TOWN OF HERNDON, VIRGINIA

ARCHITECTURAL REVIEW BOARD
VIRTUAL PUBLIC HEARING AGENDA
JANUARY 20, 2021
HERNDON COUNCIL CHAMBERS BUILDING
765 LYNN STREET
7:30 P.M.

Subject: ARB #20-027, 1025 Herndon Parkway Master Sign Plan Update

Illuminated Letter Detail - Remote Flush Mount

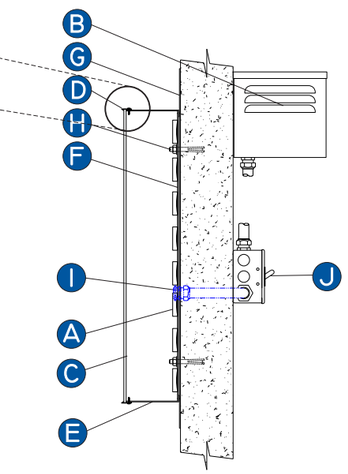
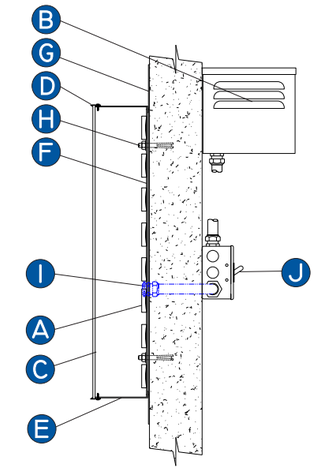
Since the work session, the applicant has opted to retain its original sign design while further illustrating how the trim cap design will look using the proposed design (Attachment #1). Staff's position remains unchanged and recommends a different sign design with a metal, reverse channel letter sign that is non-illuminated or a halo-lit 3" deep reverse channel letter design with 2"-3" spacing offset form the building wall plane to allow for the halo-lighting effect with internal white LED lights. Staff is not recommending any alterations to the lettering size or font nor any alterations to the proposed corporate logo design/form, only materials.

2. **The sign shall be constructed of 1" metal, reverse channel letters and forms, pin-mounted to the existing brick façade using the proposed sign lettering, size, font, arrangements and the logo form/design as originally proposed; and**
3. **The applicant shall be required to submit revised sign design materials meeting Conditions #1 and #2 to Town staff prior to issuance of a building permit for the proposed sign.**

EAST PARTIAL ELEVATION

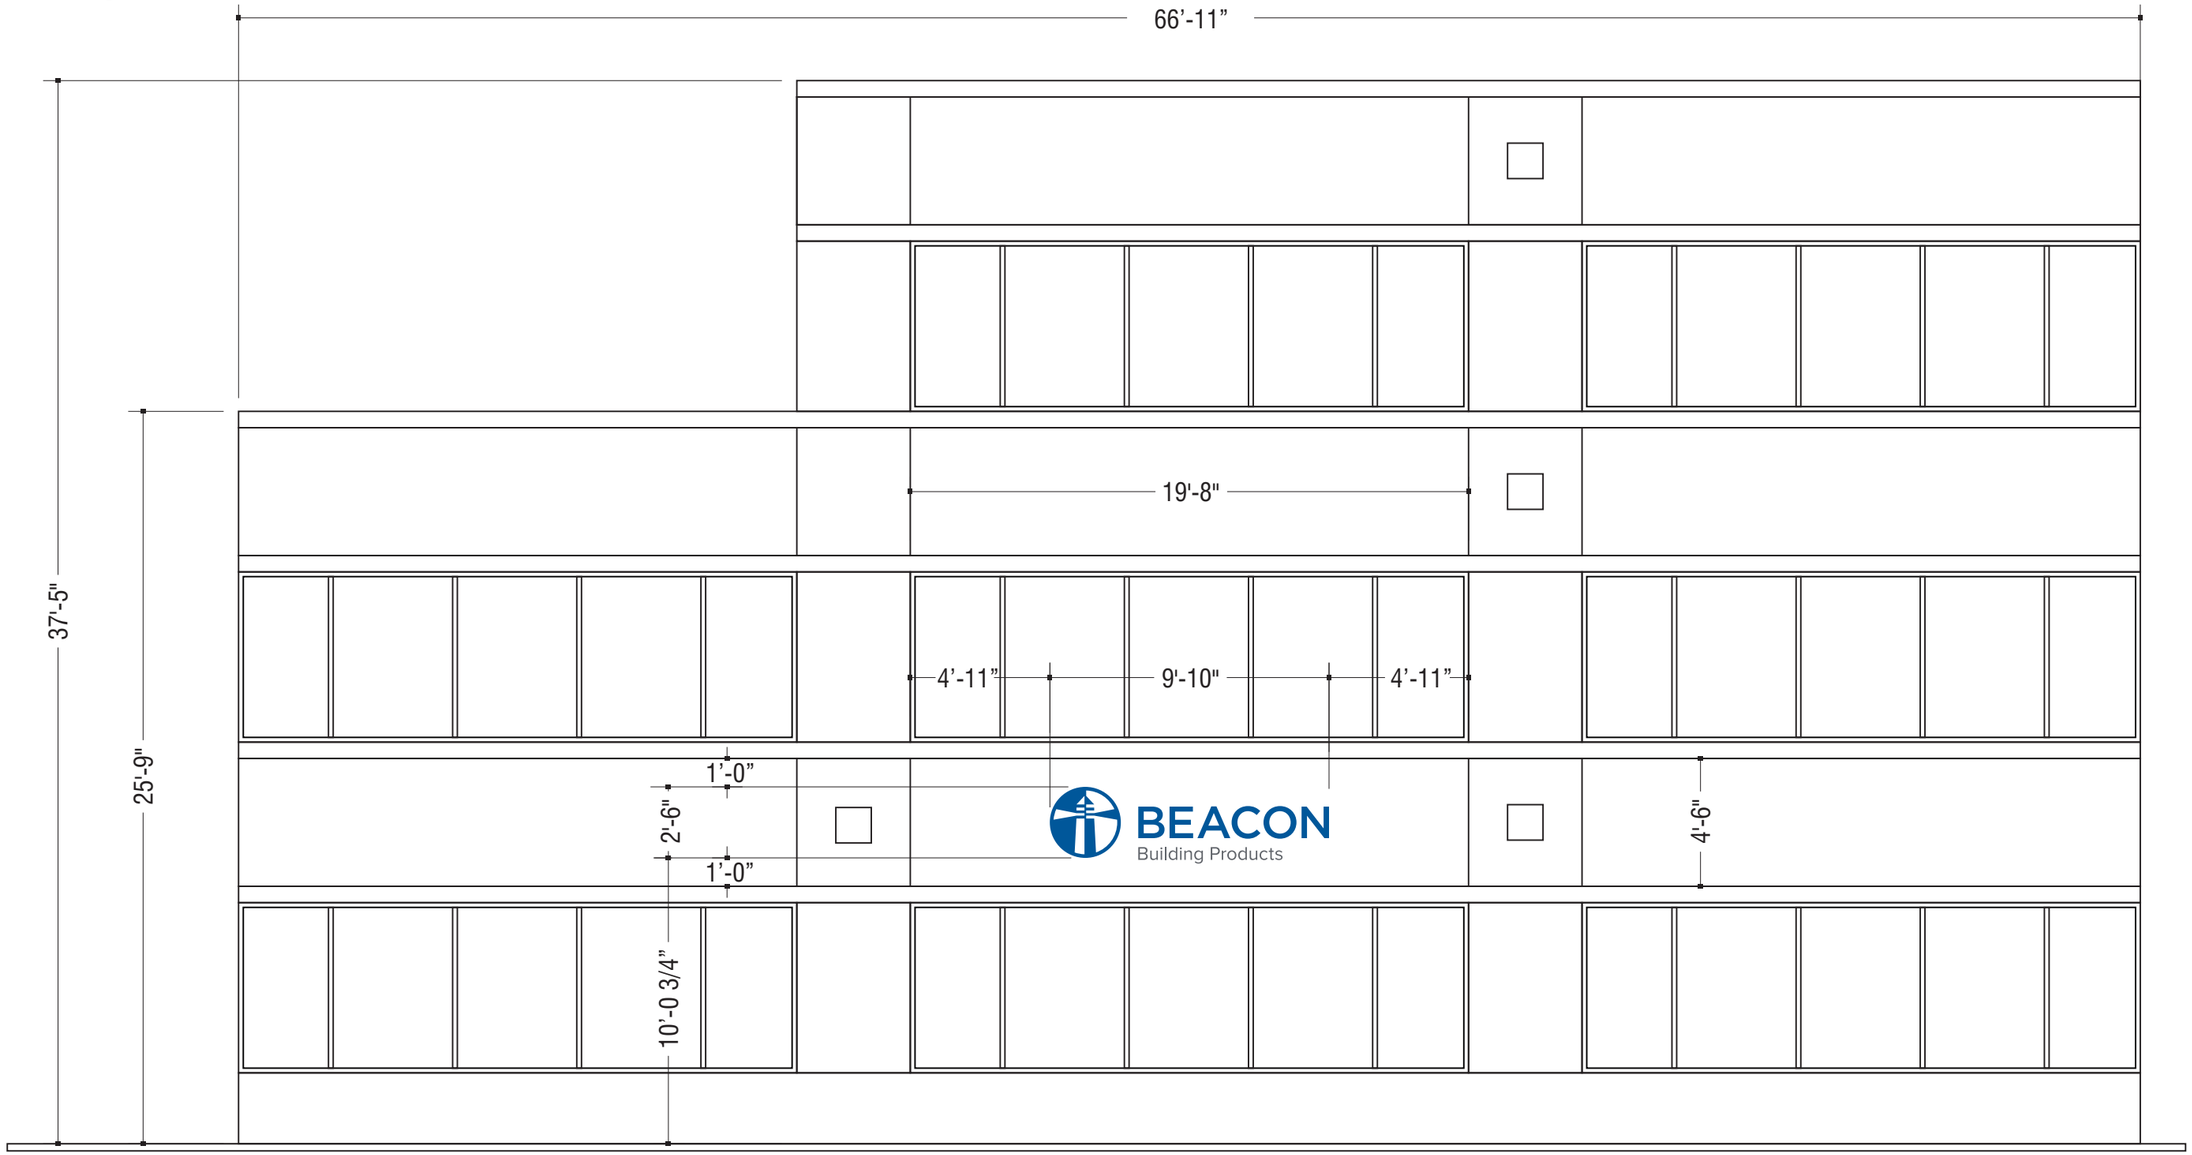
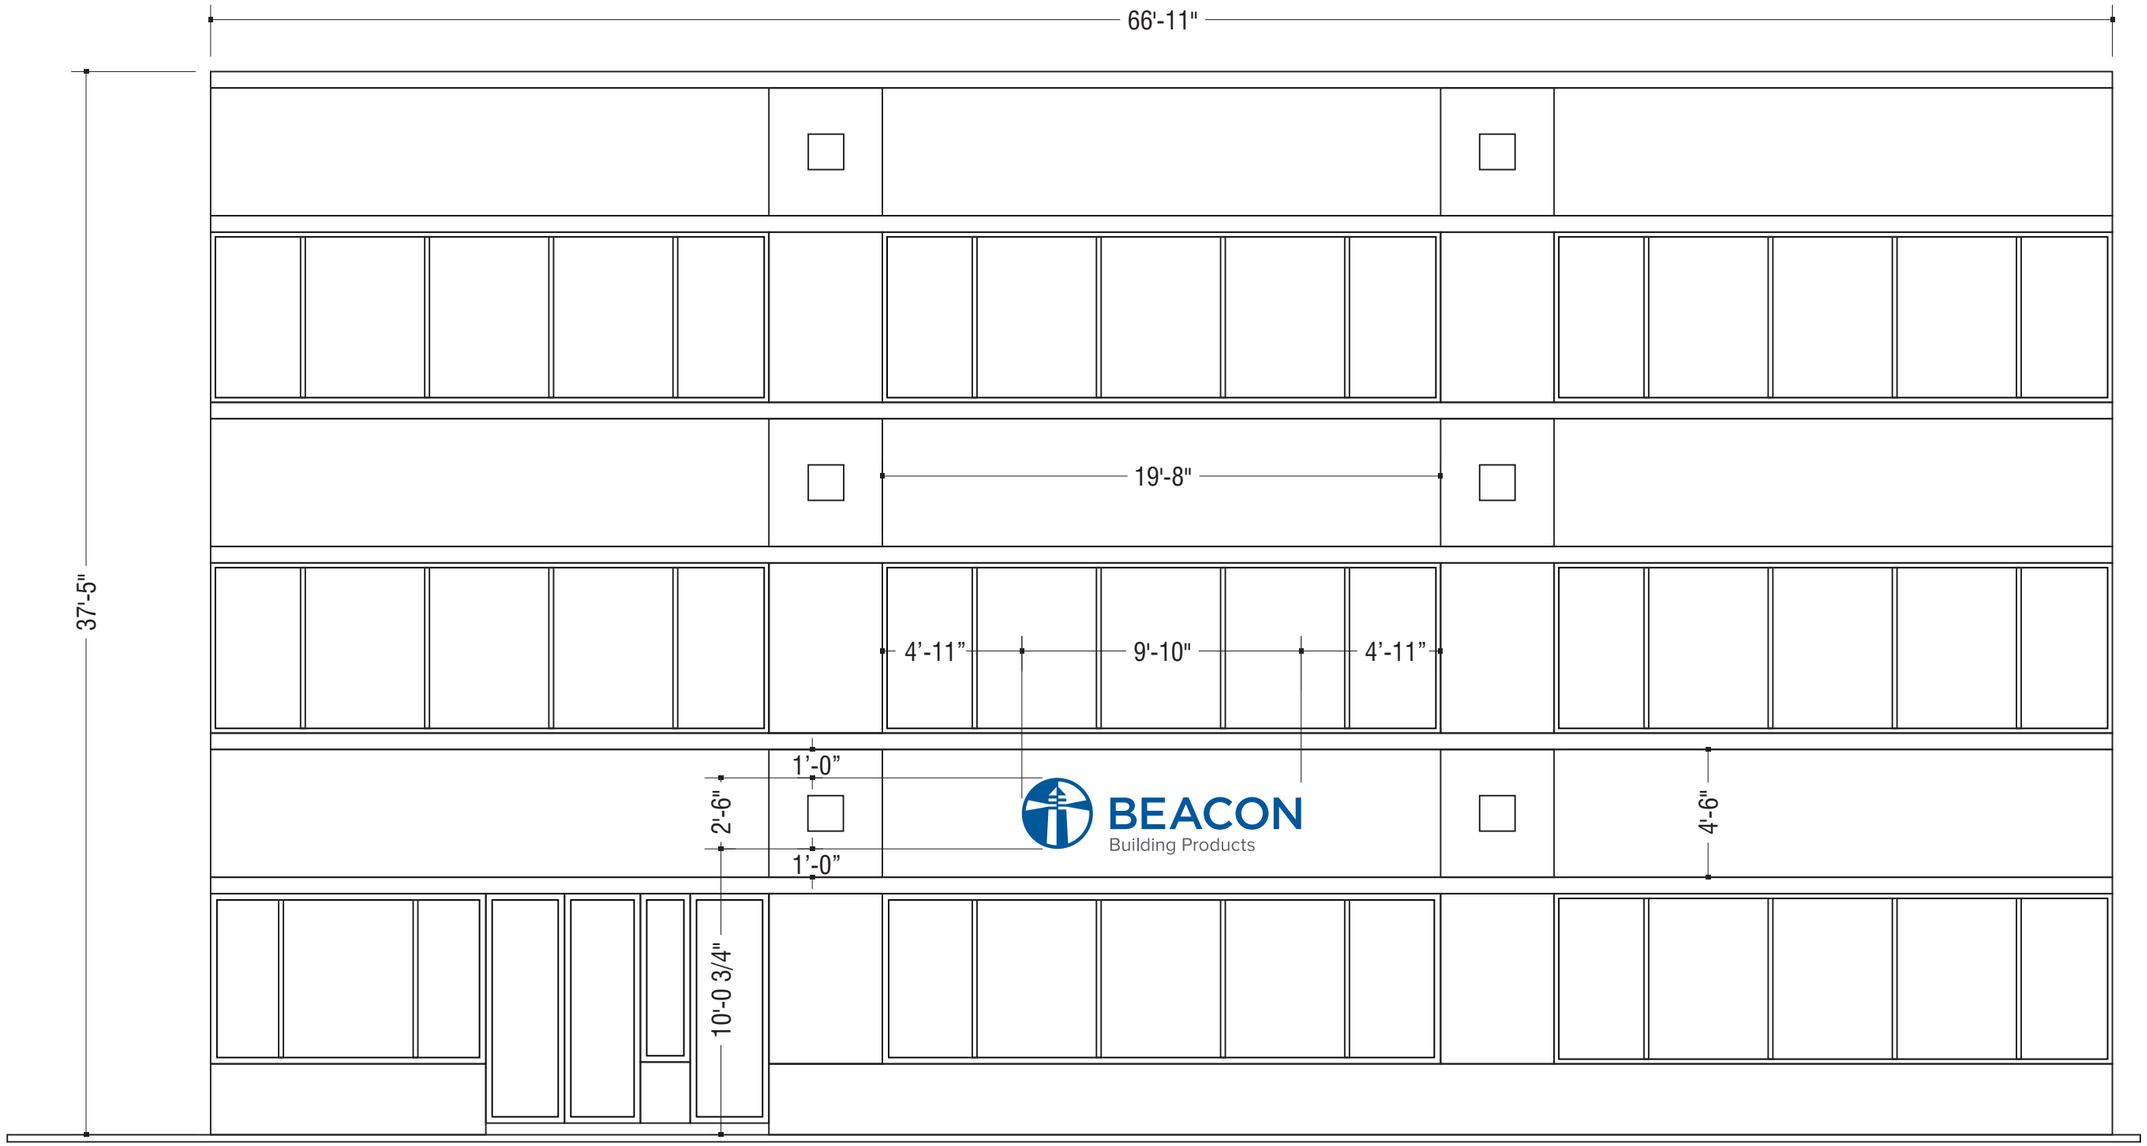
At the January 6, 2021 ARB Work Session, staff presented recommendations for an alternative sign design that would be made of dimensional metal or similar non-illuminated signage, indirectly illuminated or at most, halo-lit, that would be more appropriate for an office building and more in alignment with the approved Master Sign Plan. Staff, at that time, had withheld its recommendation due to a potential zoning compliance issue related to face-lit signs adjacent to residential zoning districts. In the course of the work session presentation, staff informed the Board that the Town's Zoning Administrator had determined that the proposed wall sign along Spring Street, on the east complied with the Town's Zoning Ordinance, and that staff would return to the Board with a recommendation pending any updates from the applicant. Two Board members agreed with the staff comments regarding an alternative sign design described in the staff report dated January 6, 2021.

1. **The sign shall be centered horizontally over the respective window bays on the first floor and centered vertically between the bottom brick**

header course and the top brick header course between the first and second floor; and
